Benicia Refinery • Valero Refining Company - California

April 15, 2022

Draft Language Industrial Hydrogen Plants
Regulation 13, Rule 5
Valero Comments

Figure 1 – Flare Vent Gas Volume

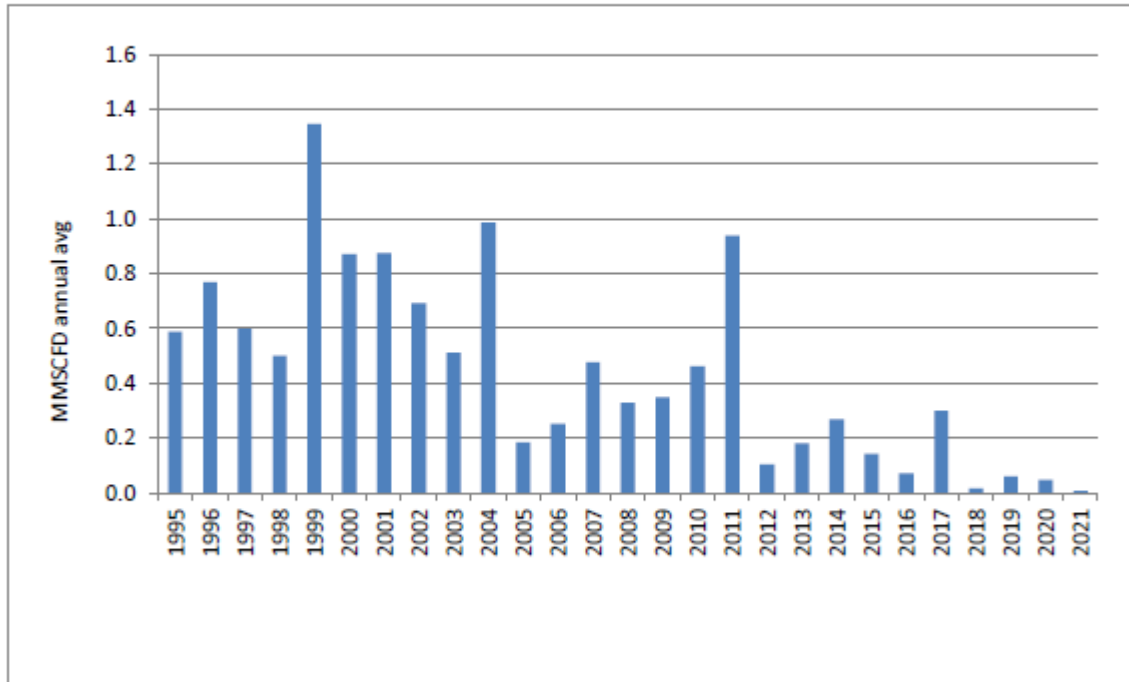
As noted above and expressed to BAAQMD staff, Valero supports adoption of a Hydrogen Venting Minimization Plan instead of a strict methane or TOC limit. In order to comply with the strict limit, the only feasible method of compliance is using a new and or existing flare. The flare will be a permanent source of criteria, toxic, and greenhouse gas emissions including an increase in NOx emissions by 1.3% as noted by BAAQMD staff at the Feb. 28th, 2022 Stationary Source and Climate Impacts Committee meeting. A minimization plan will still result in some methane emissions from hydrogen plants, but will result in less overall impact to the environment.

The graph below illustrates the success of reducing flaring at our facility through the Flare Minimization Plan.
